Our Ref / Ur n-àireamh-iùil: 16/02464/FUL & 16/05382/FUL  
Your Ref / Ar n-àireamh-iùil:

Date / Ceann-là: 06 December 2016

**Planning Permission 16/02464/FUL - Installation of an Ultra Violet Treatment Plant at the Ardersier Wastewater Treatment Plant at Land 40m West of Wastewater Treatment Works, Ardersier**

Drawing Title  
**SITE LAYOUT PLAN LANDSCAPING - SECTION A-A**

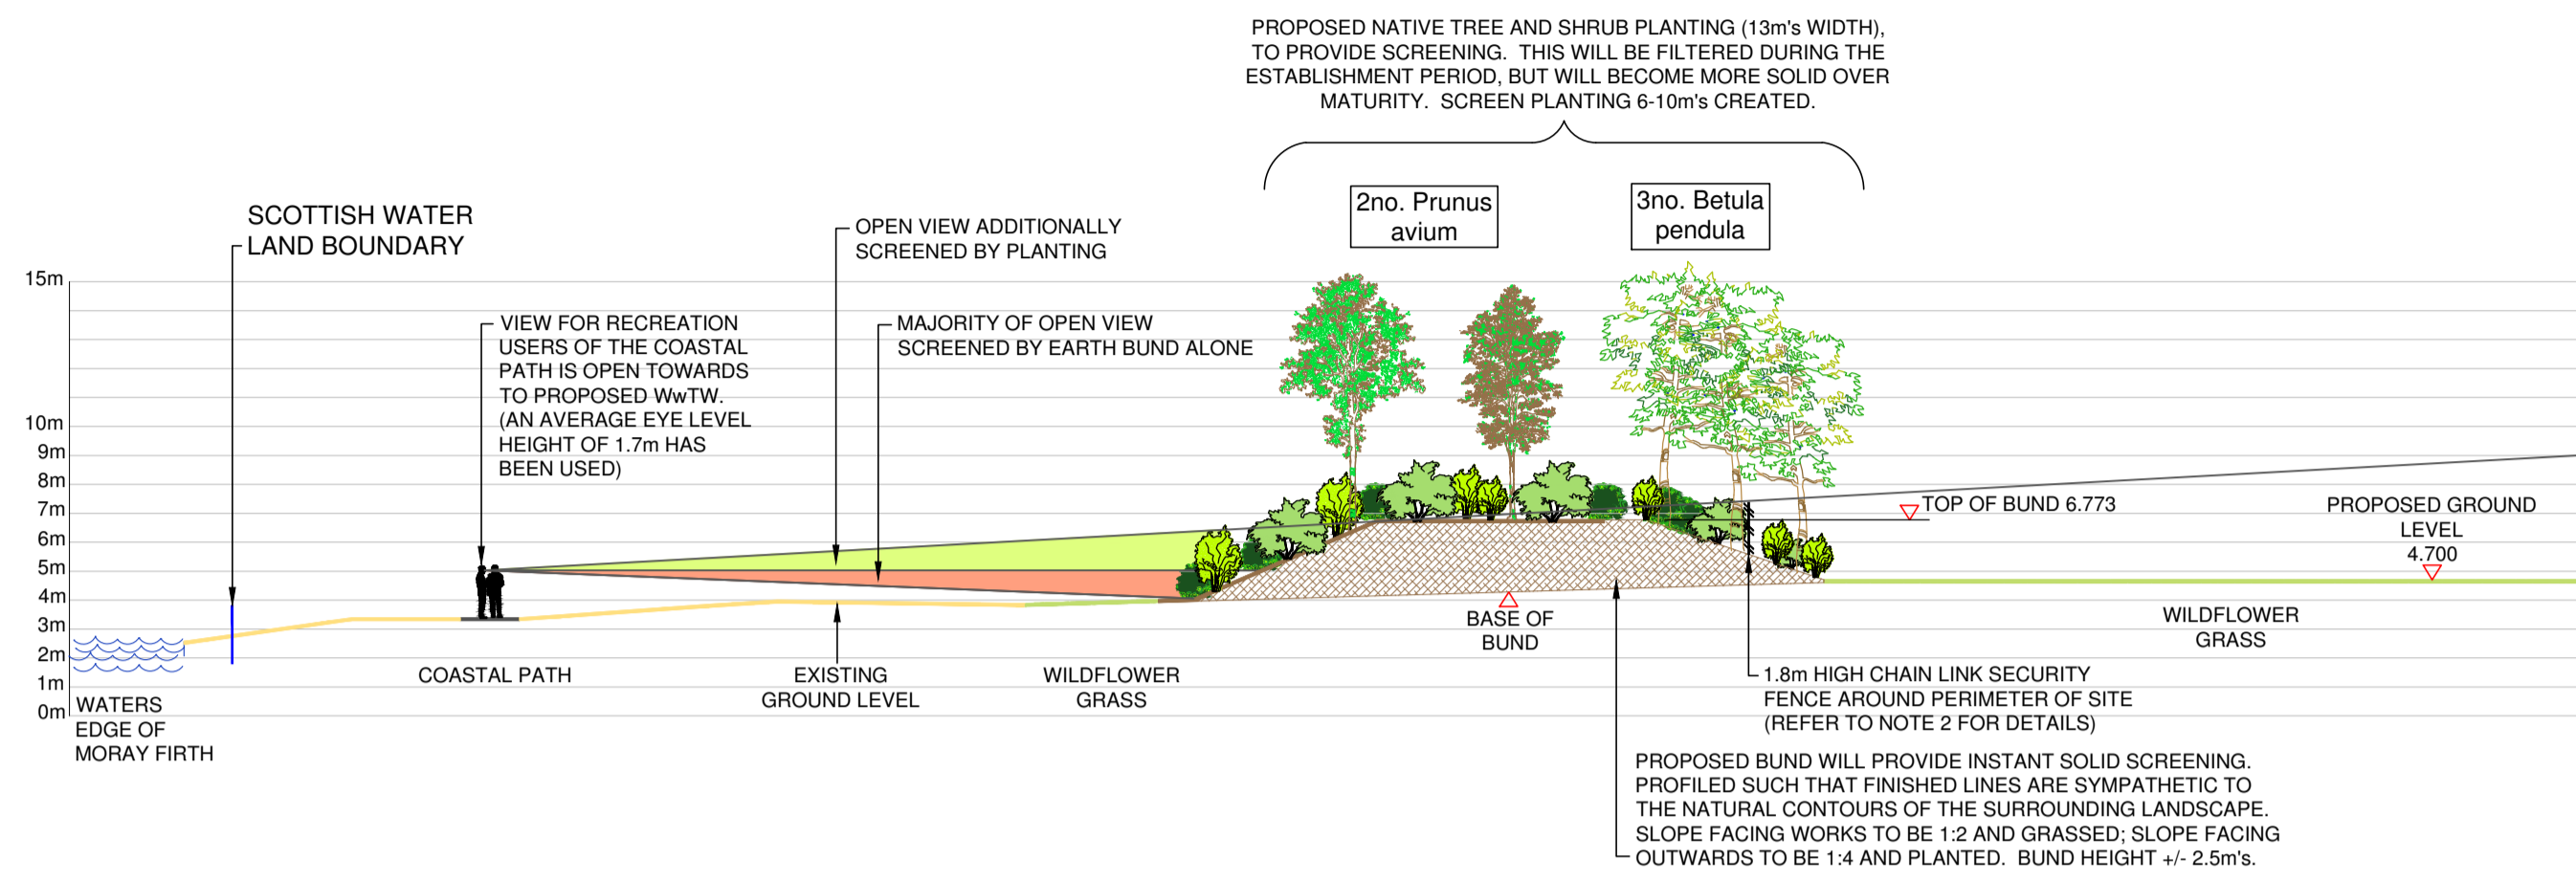
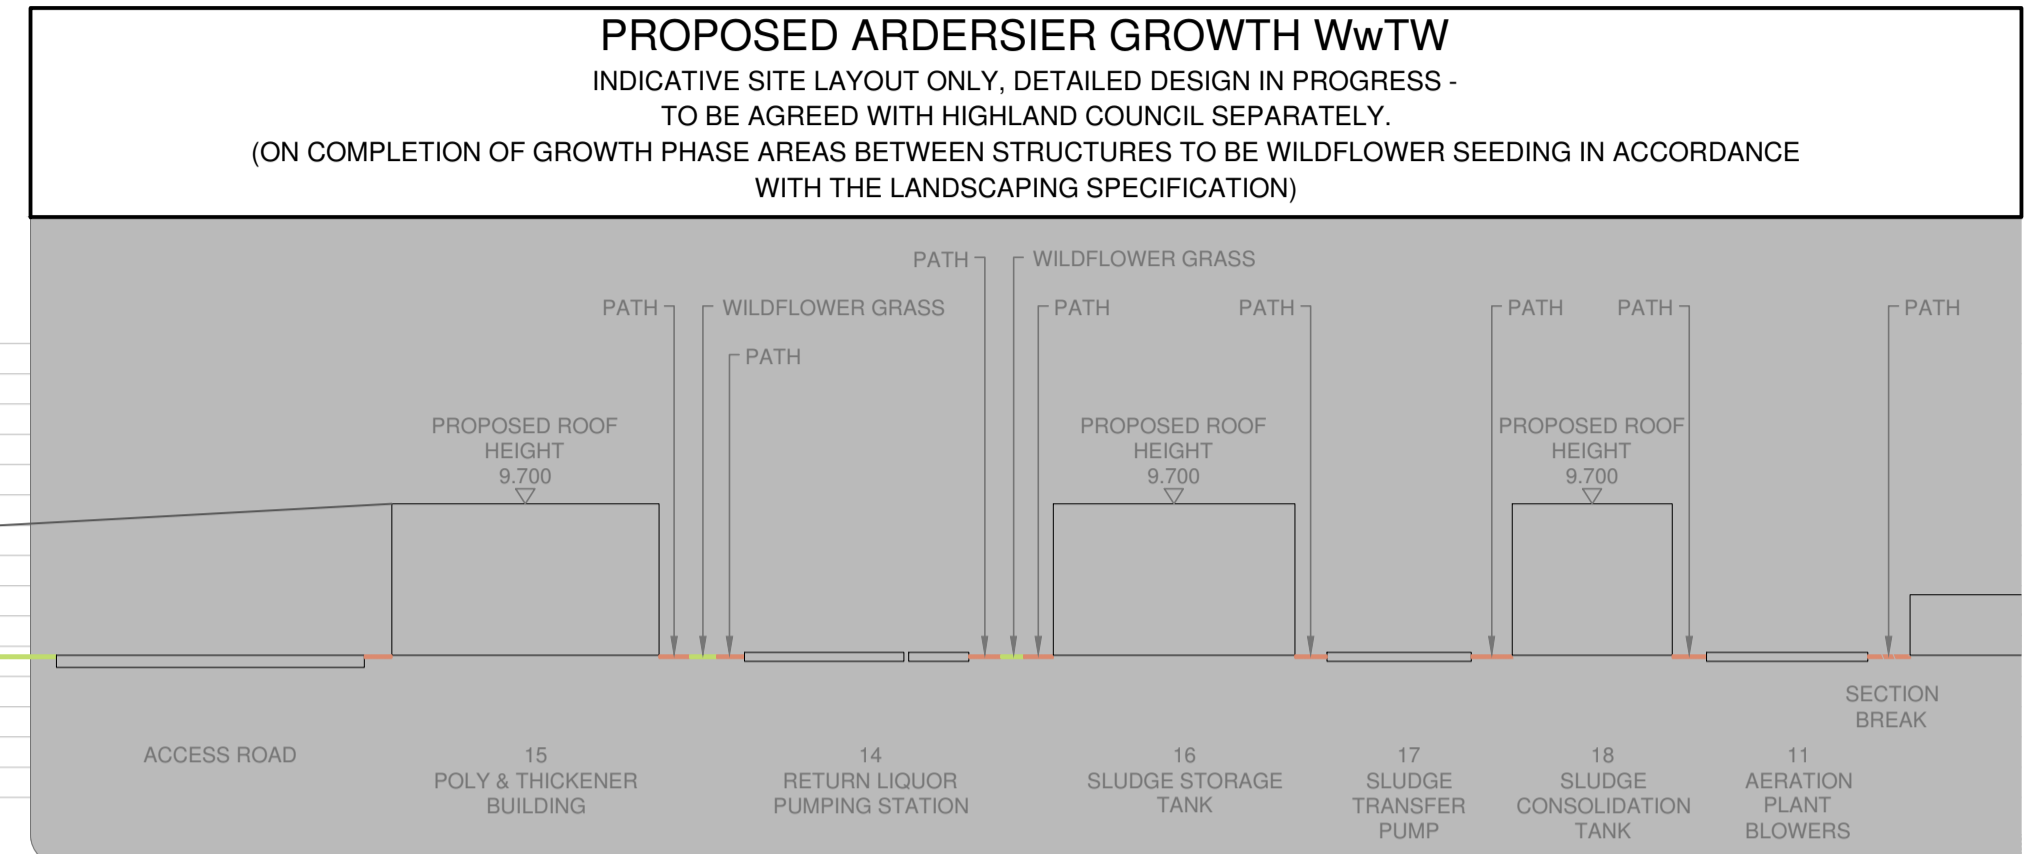
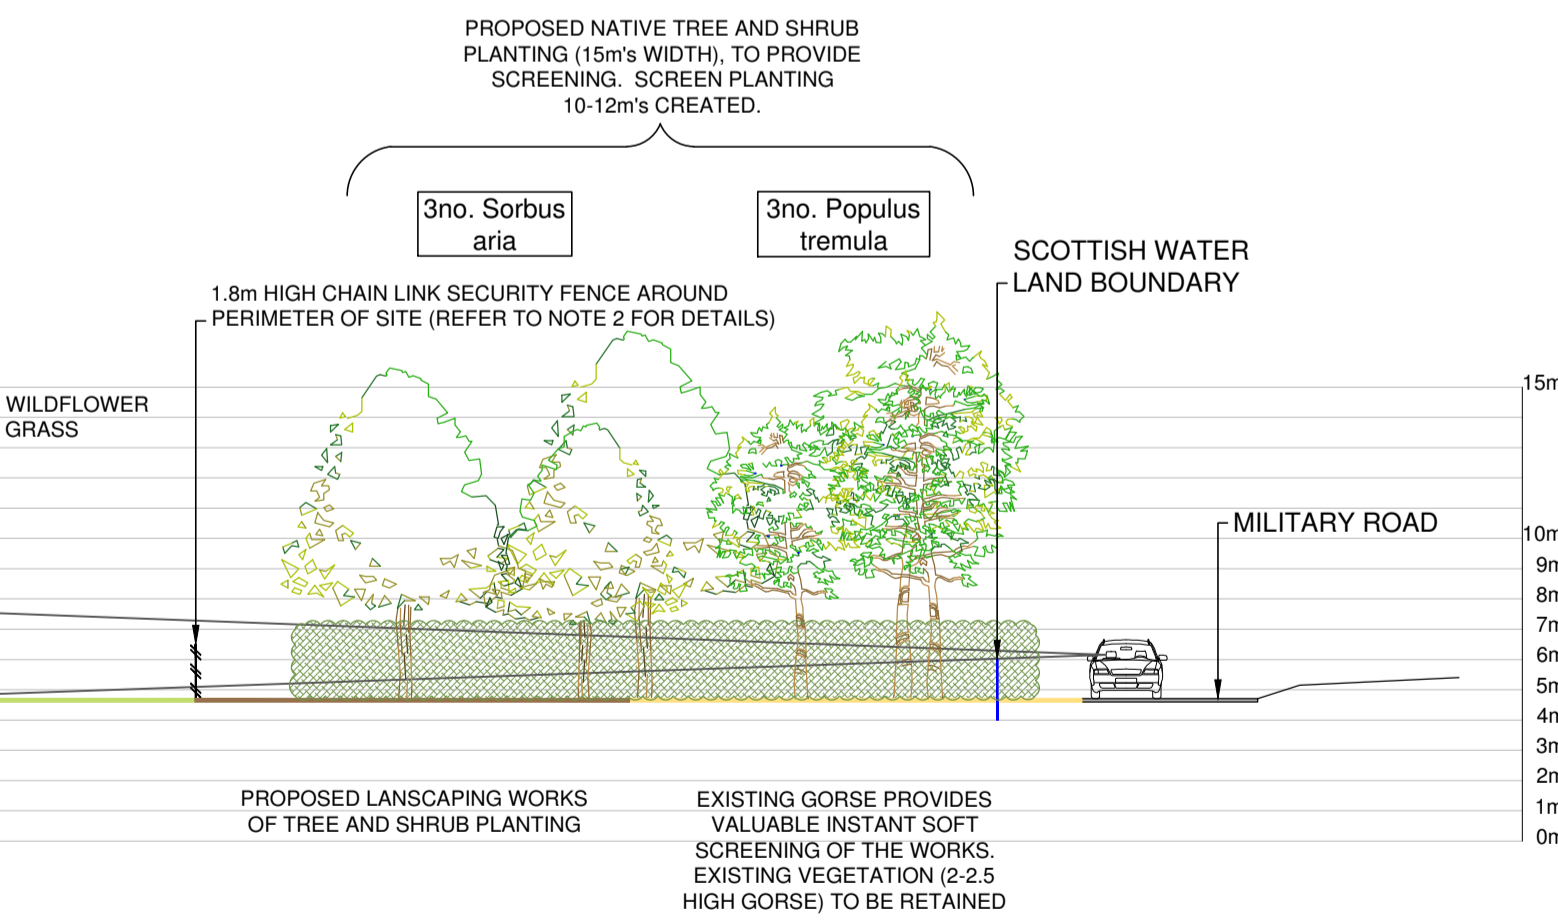
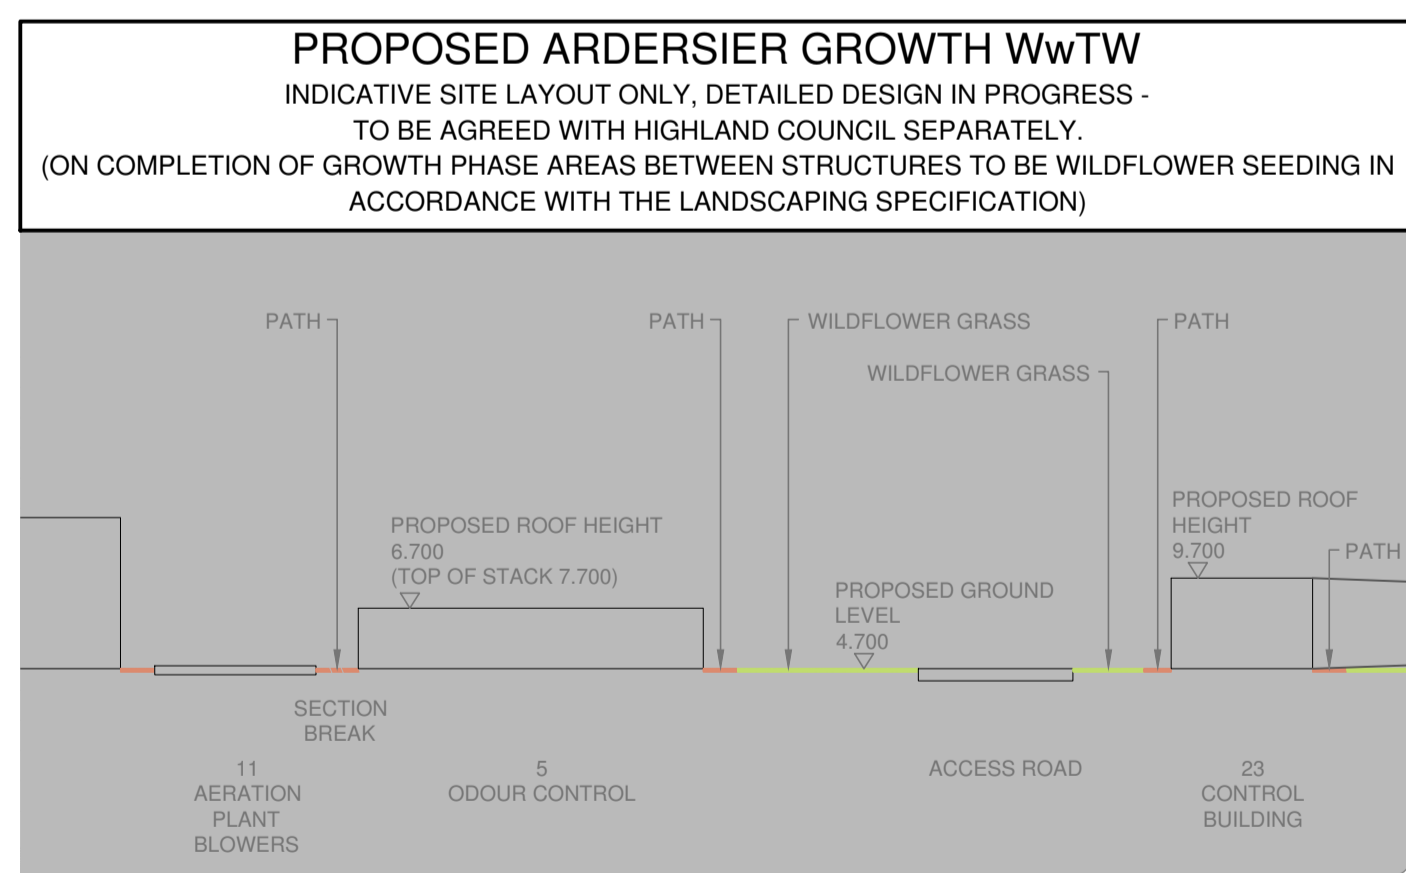
Having reviewed the submitted plans and information I am content that the level of landscaping proposed and the planting mix is appropriate to the site. I am also content that the fencing proposed is sufficient. In considering whether these accord, I have considered the location of the site and the surrounding sensitivities including, but not limited to, climate, existing planting / landscaping and nature conservation. As such the following plans are hereby approved:

- Drawing Title: Site Layout Plan Landscaping - Section A-A, Drawing Number 5000061980-WW-DRA-04158003-0C, Dated 02/12/16, Prepared by ESD for Scottish Water and submitted to the Planning Authority on 02 December 2016.
